## **Central Planning Authority**

**Agenda** for a meeting of the Central Planning Authority to be held on March 31, 2021 at **10:00am, in Conference Room 1038, 1<sup>st</sup> Floor, Government Administration Building, Elgin Avenue.**

**CPA/07/21**

Figure 1: The site (outlined in blue) is mostly man-modified (beige/brown) with some areas of seasonally flooded mangrove forest (pink).

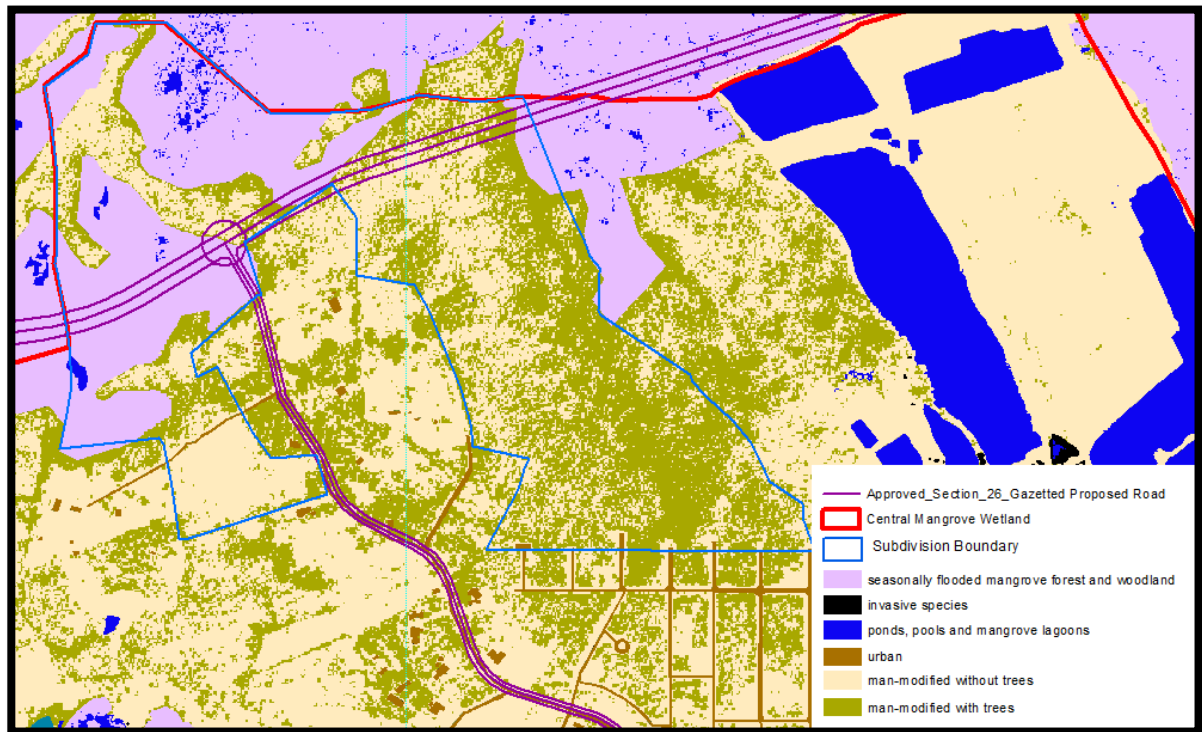
The application site is partially man-modified with areas of primary habitat (seasonally flooded mangrove forest) as shown in Figure 1. The vegetation in the man-modified areas has regrown somewhat and continues to provide an ecological benefit, such as drainage and habitat for native flora and fauna. The application site is also located immediately south of the Boundary of Central Mangrove Wetlands (see Figure 2). Therefore given the size and location of the subdivision, the Department would like highlight the following concerns.

Figure 3: An extract of the Plan over the LIS 2018 aerial image, with the Central Mangrove Wetland boundary (orange red line).

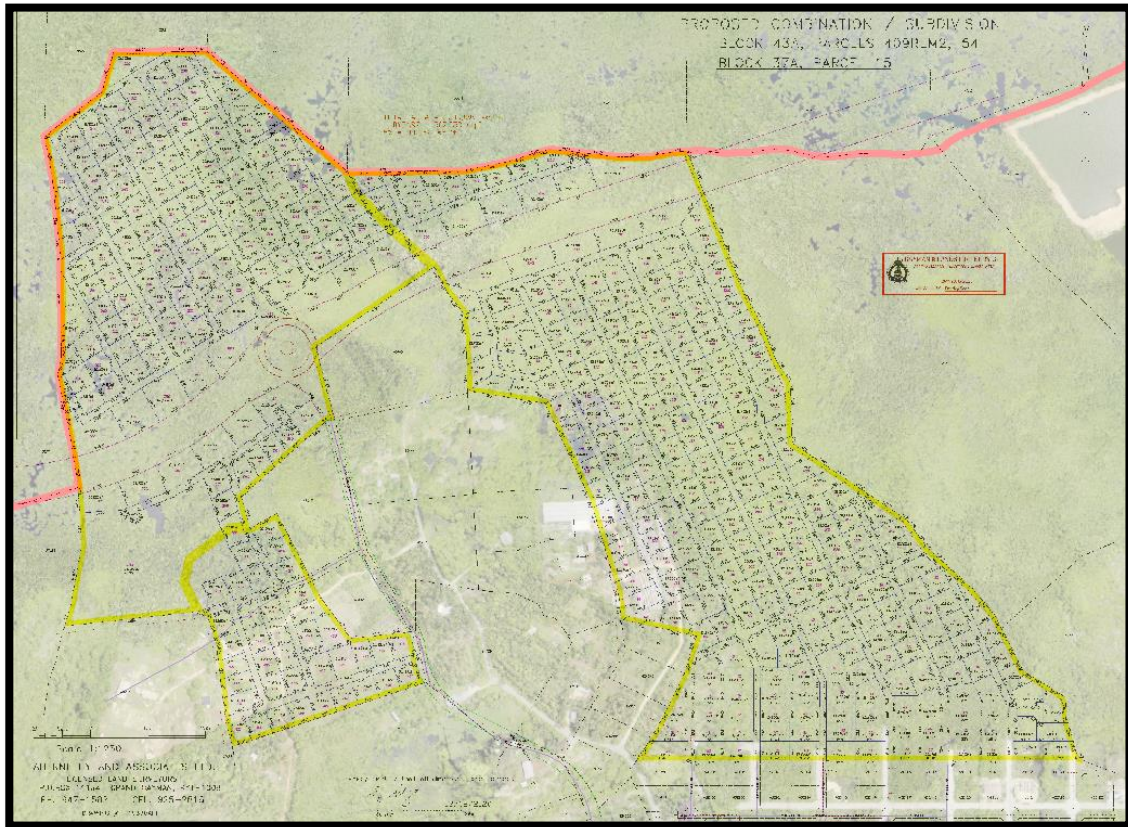
*The Development Plan is severely outdated. It does not reflect accurately how the island should be developed moving forward taking into consideration the population size, projected population growth, the environment and climate change. Therefore, without an updated development plan for the islands, there is no vision on how the island should progress in terms of development. This can result in unnecessary fragmentation of pristine habitats and loss of valuable limited resources (such as land and associated ecosystem services). It is recommended that prior to approval of this subdivision, the supply and demand of residential lots should be determined. The current Lookout Gardens Subdivision is approximately 40% built out, which raises the question*

of the need for the proposed subdivision development when more than 50% of the existing subdivision remains undeveloped and within the ownership of the original developer.

*Figure 1: A habitat landcover map showing the area of the proposed helipad (orange)*  
Please do not hesitate to contact the Department should you require further assistance.

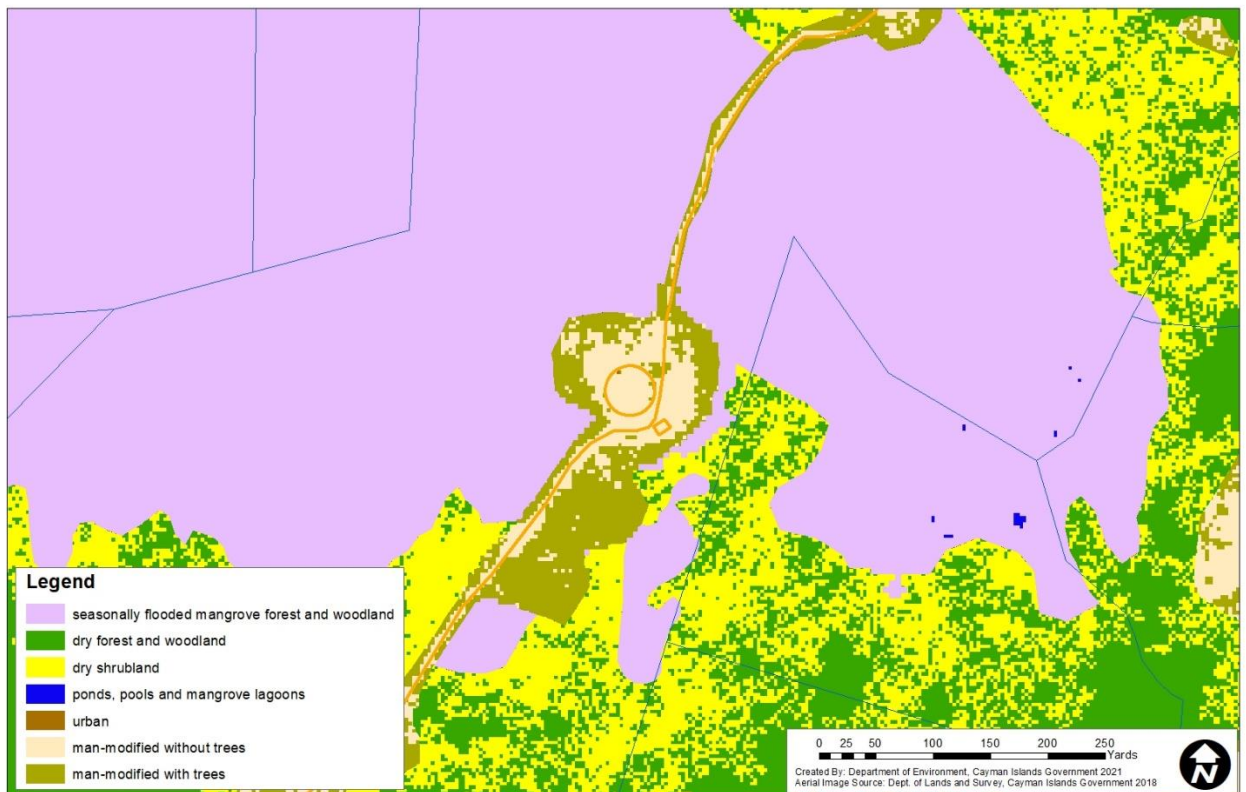
*Although the helipad is proposed in an area that is considered to be of ecological importance, with Malportas Pond to the north and the Mastic Trail to the east, the distance between these and the helipad is generally considered to be enough of a buffer to mitigate many of the significant concerns of disturbance to the ecology of the area. The alignment of the flight path from east to west means that the concentration of bird life surrounding Malportas Pond is less likely to be impacted in particular. In regards to the direct impact to the immediate area of the helipad itself, the footprint of it and the proposed parking are located in an area of previously cleared man-modified (as shown in figure 1 below) meaning that its impact is of limited ecological concern. For the most part the potential concerns regarding this proposal relate to the nuisance to surrounding land uses and residences rather than environmental concerns.*

Figure 5: DOE drone imagery taken 28 Jan 2021 showing the impacted area (outlined in red) on the application site

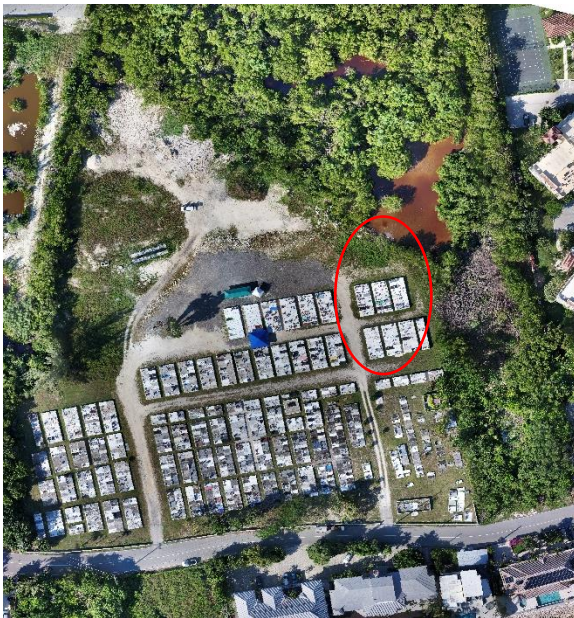
*The DOE responded to reports of heavy equipment working on site on 21 January 2021 and mangrove habitat being cleared (See Figure 3). The Department of Planning confirmed that permission had not been granted for these works. The DoE issued a Cease & Desist Order to the applicant under section 33 of the National Conservation Law (NCL). It was also noted during the investigation that there were mangroves further within the parcel that had been cleared on another occasion (See Figure 4). Drone imagery of the site taken on 28 January 2021 (figure 5) illustrates the extent of clearing that has taken place to the southern end of the site (which was not the subject of the Cease & Desist Order).*
